PROJECT :	KOTHAGUDEM THERMAL POWER STATION STAGE-VII, UNIT # 12 (1X800 MW), KOTHAGUDEM, TELANGANA, INDIA COAL HANDLING SYSTEM PACKAGE
-----------	---

TITLE : GA OF BC#3A/3B
---	------------------------

SCALE	BHEL JOB NO. IS-1-14-2006	BHEL-ISO DRG. NO.: IS-1-GA-690-101-M009	REV. 01
-------	---------------------------	--	------------

COMPLIANCE REPORT

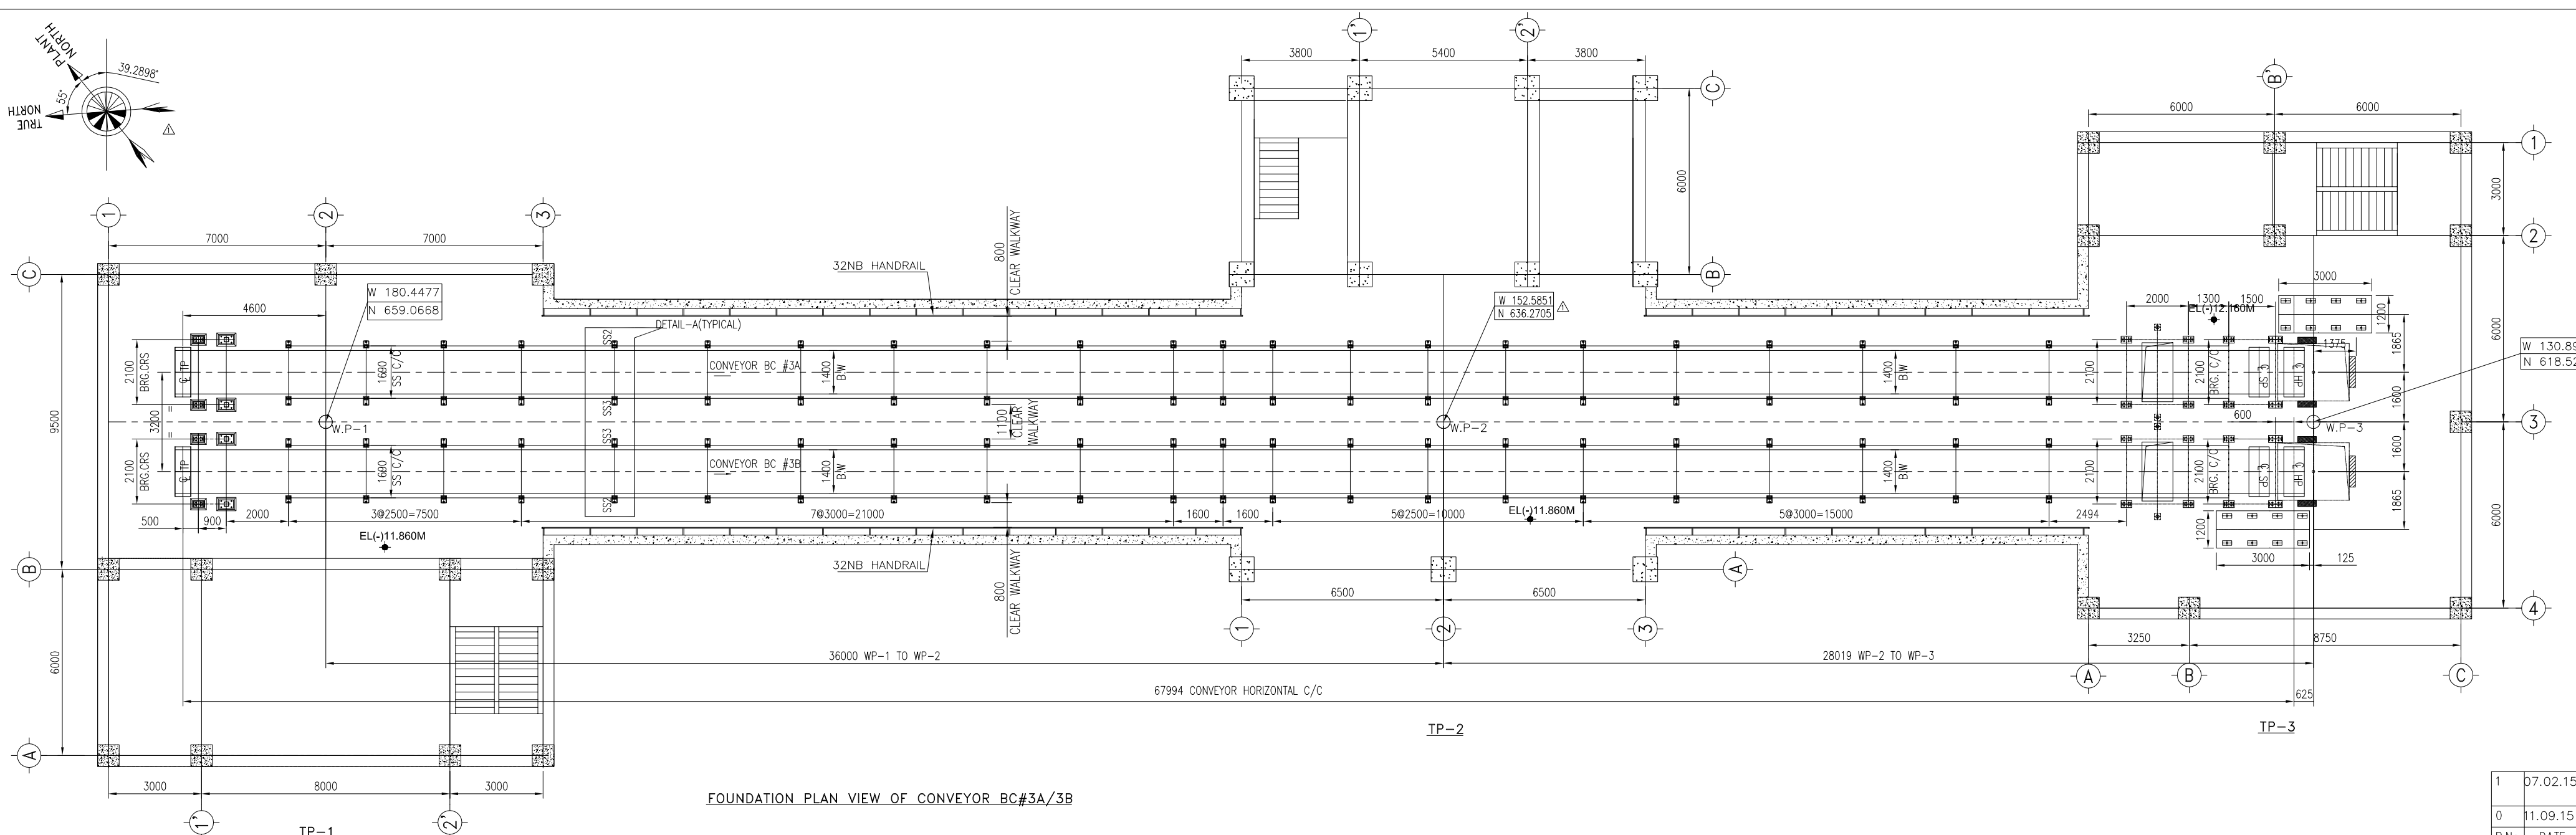
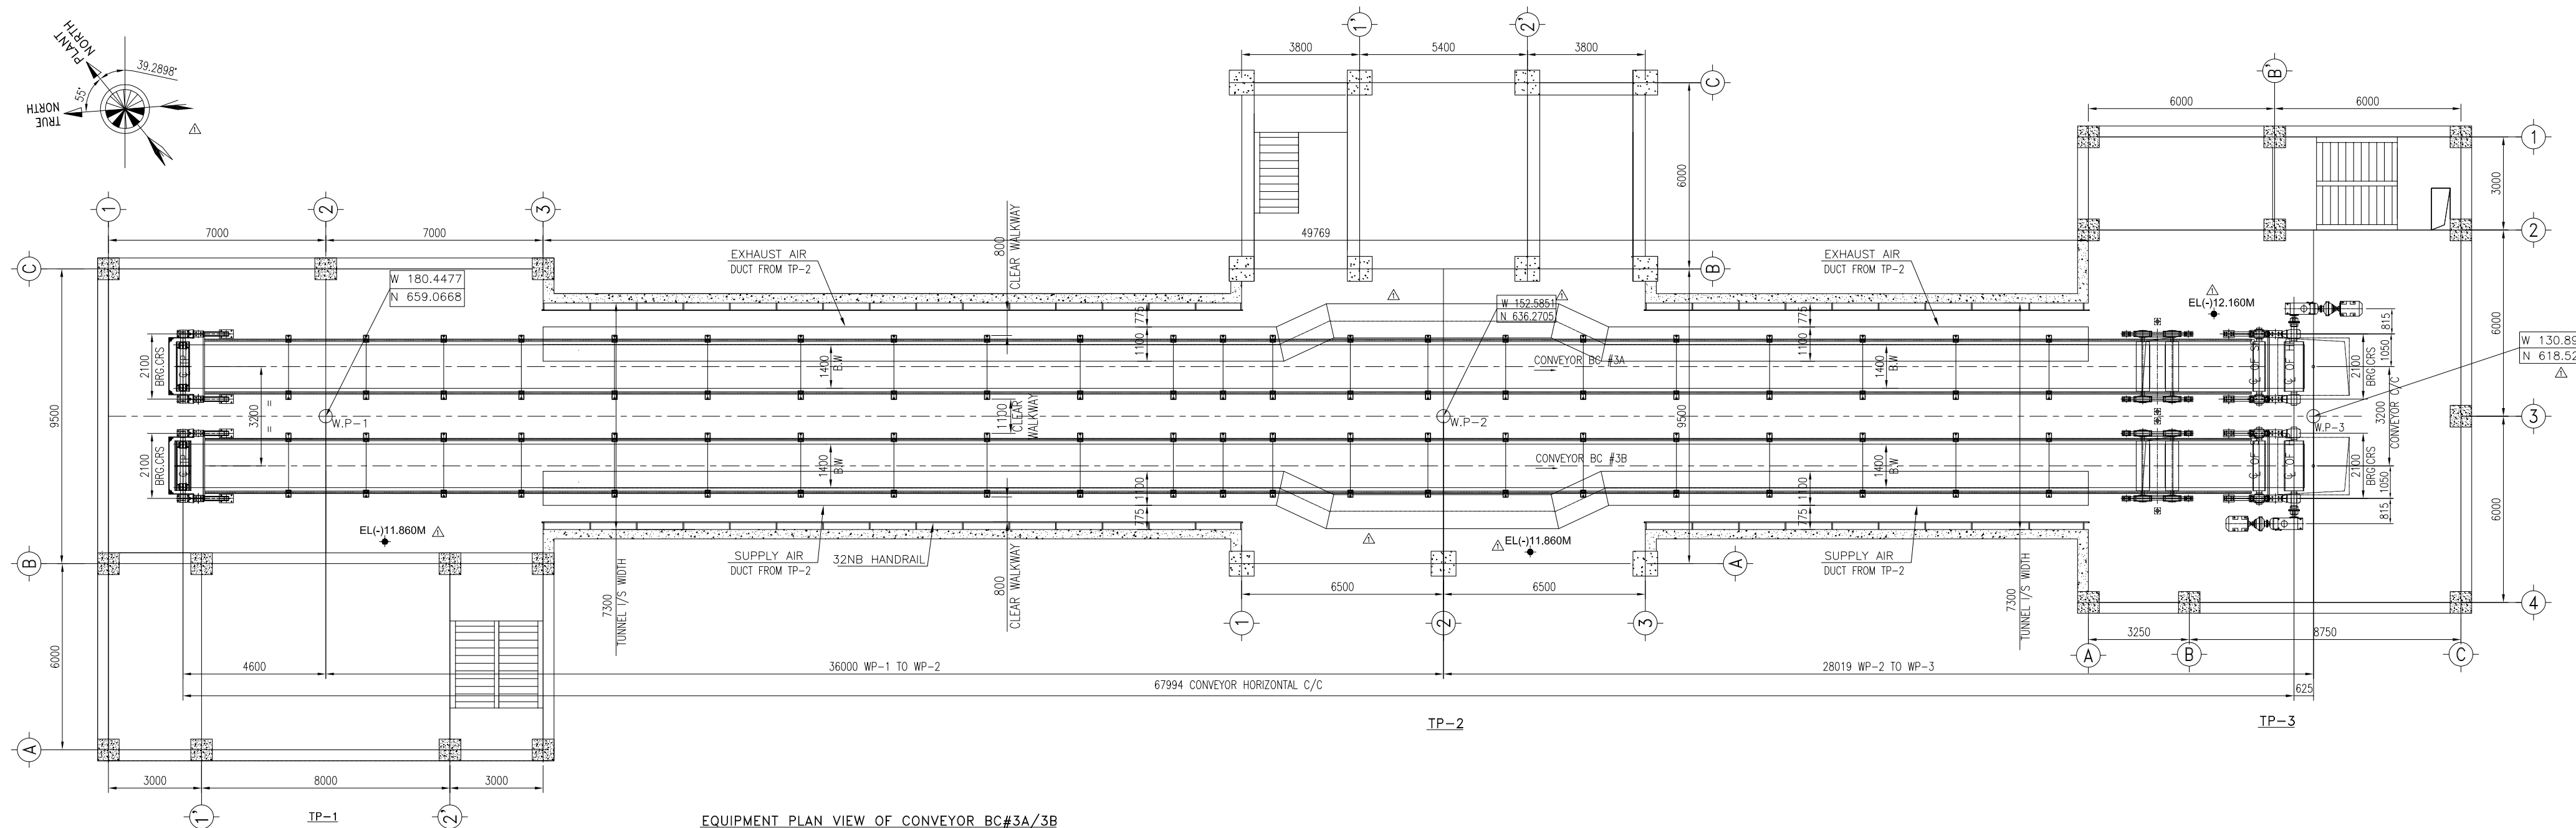
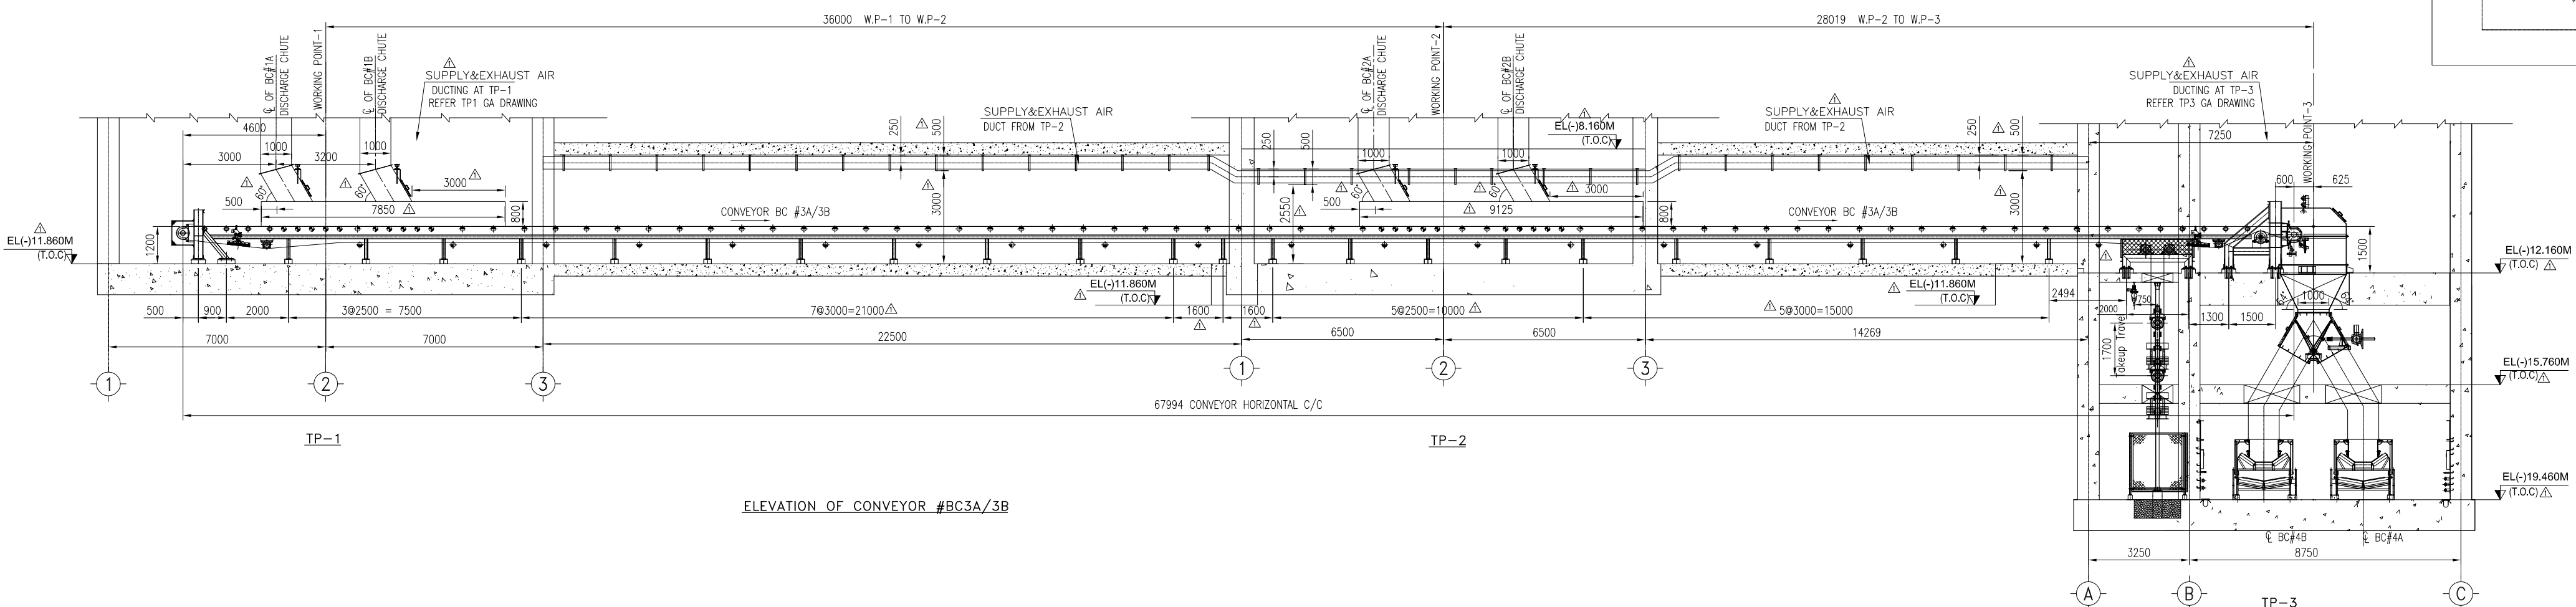
Sl.No	Owner/Owner's Consultant's Comment	BHEL Reply	Comments/Conclusion by Owner/Owner's Consultant
A	Sheet 1 of 2		
1	Indicate Chute angle? (Typ.)	Noted and incorporated in revised document	
2	Cutout dimensions,centerline & elevation of duct to be indicated	Please note that clear headroom and duct dimension indicated. For duct dimensions clearances ,openings,etc in the TP's please refer to respective transfer tower GA drawing	
3	Mention clear height inside tunnel inline with spec.	Noted and incorporated in revised document	
4	Skirt board length & height to checked w.r.t. DS system	Skirt board dimensions are 3000mm ahead of front edge and 500mm behind rear edge of chute with 800mm height, which will take care of DFDS system requirement.	
5	Monorail & hoist to be shown. EL from bottom of monorail to be indicated.	Please note that this is the conveyor GA drawing and details related to conveyor alone(starting from bottom of skirt board top sheet to discharge chute flange) will be indicated in here. For the details of floor openings, handling arrangement,cut outs, duct locations in the transfer tower area please refer to the respective transfer tower GA drawing. As duplication of information will lead to discrepancy

6	Lifting arrangement not shown		
7	Furnish flap gate no.		
8	Elevations not matching with conveyor profile GA bearing drg no. IS-1-GA-690-101-M004, Rev. 00	Updated as per the latest conveyor profile GA drg no. IS-1-GA-690-101-M004, Rev. 02	
9	Indicate floor opening dimensions	Noted and incorporated in revised document	
10	Indicate walkways (Typ.)	Noted and incorporated in revised document	
11	Please note that while revising Mech. GA of any conveyor, please consider the comments mentioned here	Noted	
12	Mention minimum clear height available	Noted and incorporated in revised document	
13	For comments on VGTU, refer detailed view in next sheet	Noted and suitably incorporated in revised document

14	1. Show walkway (Side & Central) in both plan and elevation views. Please note that clear height of 3.5 M (Min.) to be provided in tunnels. Please indicate the same in drg. / 'Note'. 2. Show atleast one cross over through the length, 3. All co-ordinates need to be checked with Plot Plan & TP GA	1) Walkway indicated in elevation and plan views. Please note that as per the specification 'Noted and incorporated in revised document e-PCT-TS-K-02-2014-15-Vol-IVA, Page no. 27 , Caluse 07.14.02 conveyor galleries, the clear height in gallery and tunnel is 3m. The same is considered. 2) Please note that the as per specification cross overs to be provided at every 100m. In this case as the tunnel length between transfer points TP-1 and TP-3 is hardly 50m, cross over is not considered. Request to accept the same. 3) Coordinates updated	
15	Co-ordinates are not matching with TP-1 & TP-2 Mech. GA drawings. Please check.	Noted and incorporated in revised document

16	Indicate monorail, various openings / cutouts	Please note that this is the conveyor GA drawing and details related to conveyor alone(starting from bottom of skirt board top sheet to discharge chute flange) will be indicated in here. For the details of floor openings, handling arrangement, cutouts, duct locations in the transfer tower area please refer to the respective transfer tower GA drawing. As duplication of information will lead to discrepancy	
17	Indicate monorail		
18	Indicate platform level here	Noted and incorporated in revised document	
19	Provide cross sectional view	'Noted and incorporated in revised document. Please note that all the cross sections of conveyor both in tunnel and in gallery are furnished in drawing "typical conveyor cross section.(IS-1-GA-690-100-M003)". The same is indicated in reference drawing list.	
20	Indicate ventilation duct dimensions, distance from columns, cutouts here	Noted and incorporated in revised document. For duct dimensions clearances ,openings,etc in the TP's please refer to respective transfer tower GA drawings

21	Indicate conveyor location, No. of feeding points & wrap angle	Noted and incorporated in revised document	
22	Please update this table as per DCPL comments in Conveyor calculations	Noted and incorporated in revised document

23	Please indicate imported / indian coal considered here, if blended, mention % also.	Noted and incorporated in revised document	
24	Heady duty for conveyor belt	Noted and incorporated in revised document	
25	Please indicate the nomenclature for T1, T2, T3 & Te	Noted and incorporated in revised document	
26	Indicate spacing of idlers	Noted and incorporated in revised document	
27	Indicate the type of hold back whether it is integral	Noted and incorporated in revised document	
28	Please note that brake shall be provided wherever coasting time comes positive in calculation. No deviation is acceptable.	Please refer to the latest coasting time calculation document (Rev-01) with compliance for non provision of brake	
29	Please note that as per clause no. 7.09.08, it is clearly indicated that 'Take-up weight material shall be made of cast iron blocks.' Please provide the same accordingly. Also Indicate weight of each segment of counter weight and the nos. to be provided	Noted and incorporated in revised document

30	Location of scrappers to be indicated. Please note that internal scraper to be provided near tail pulley & bend pulley.	Noted and incorporated in revised document	
31	Type of coupling to be mentioned	Noted and incorporated in revised document	
32	As per conveyor power calculation, HG TU has been indicated near tail end. Please check.	Please refer to the latest conveyor profile GA drg no. IS-1-GA-690-101-M004, Rev. 02 and the updated conveyor power calculation document	
33	Type of rubber and shore hardness to be indicated for skirtboard	Noted and incorporated in revised document	
34	10 mm thk for uncrushed coal for skirtboard liner	Noted and incorporated in revised document	
35	Skirtboard height to be indicated	Noted and incorporated in revised document	
36	Include coupling guard in the table	Noted and incorporated in revised document	
37	Provide stringer & short support calculation	Short support and stringer sizing is part of fabrication detail. The same shall be suitably sized. Presently MC100 and MC125 is considered based on BHEL's experience from earlier reference projects

38	Thickness shall be 3 mm (min.) for seal plate	Noted and incorporated in revised document	
39	Indicate Grade & IS Standard of MS used	Noted and incorporated in revised document	
40	SP,BP,TU These are not mentioned in drg. Please check.	Noted and incorporated in revised document	
41	External scrapper shall be included in legend	External scrapper is not indicated in shortform, hence trhe same is not included in legends.	
B	Sheet 2 of 2		
1	SACI shall be located within 5000 mm from either end of conveyor	Updated near the discharge end side. However please note that first self aligning carrying idler (SACI) near tail end cannot be located at 5m as the same will be in the material feeding zone, wherein material load and skirtboard will prevent the belt sway and thereby presence of self alining will be of no use. Hence the first SACI is located just after the feed point.	
2	Distance of transition idler from Head pulley to be checked as it appears high.	Updated the transition idler spacing considering the maximum feasible distance.

3	TP centre line EL	Noted and incorporated in revised document	
4	Show internal scrapper near bend pulley also.	Noted and incorporated in revised document	
5	HP centre line EL	Noted and incorporated in revised document	
6	Show external scraper	Noted and incorporated in revised document	
7	Pulley diameters along with pulley designation shall be marked in drawing	Noted and incorporated in revised document	
8	Indicate distances between working points here. Mark working point 3 as shown in Elevation view	Noted and incorporated in revised document	
9	Mark all items at head pulley and tail pulley	Noted and incorporated in revised document	
10	Please mark the drive items, and indicate center line of the items	Noted and incorporated in revised document	
11	Provide grouting	Please note that grouting will be applicable where in foundation bolts are located at a later date after pedestal concreting with pockets or where uneven surfaces are there. At places where insert plates are provided, grouting is not required as the insert plate will be located while concreting ensuring even surface.

12	Furnish angles of chute	Noted and incorporated in revised document	
13	Provide stringer & short support calculation	Short support and stringer sizing is part of fabrication detail. The same shall be suitably sized. Presently MC100 and MC125 is considered based on BHEL's experience from earlier reference projects	
14	Please indicate the counter weight handling arrangement	1.5T manual hoist is provided for handling of counter weight. Please refer the transfer tower GA drawing.	
15	Indicate cut out dimensions at takeup travel area	Noted and incorporated in revised document	
16	Sand pit overall dimension and wall to be indicated	Noted and incorporated in revised document	
17	Indicate dimensions of safety mesh at takeup	Noted and incorporated in revised document	
18	Update note, 3 & 4	Noted and incorporated in revised document	
19	Indicate dimension of ventilation duct.	Noted and incorporated in revised document
